Proposed Block 2
Elevation D - Baldwins Gardens - 1:200@A1

PLANNING		©2014
Date:	Scale:	Drawn by:
MAY 14	1:100@A1, 1:200@A3	dc
Project: Bourne Estate South for Higgins Construction PLC		
Drawing title: PROPOSED BLOCK 2 Elevation D - Baldwins Gardens		
Reference:	Dwg. No:	Rev:
BE	P282	B

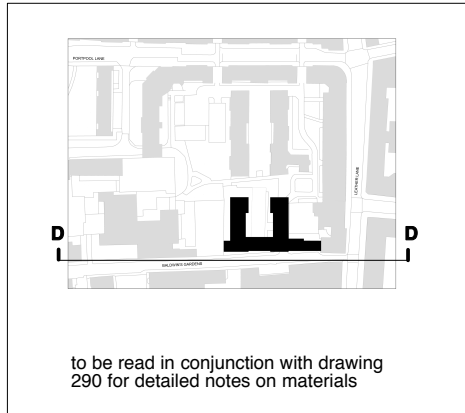
2014.09.12	B	access to new meter cupboard included; meter cupboards to units 2.4, 2.8, 2.9 & 2.10 removed from Baldwin Gardens elevation; minor fenestration changes to ground and 1st floor; minor fenestration changes to 5th floor.
2014.02.12	A	storey heights increased; 5th floor brickwork revised to type 4 (unglazed white); brick types revised to main elevation; Juliette balconies removed to central 3rd and 4th storey windows over archway; white brick banding revised from brick type 2 to type 4 and banding depth increased; white brick to arch face revised from type 2 to type 4; minor window revisions to 5th floor.
Revisions:
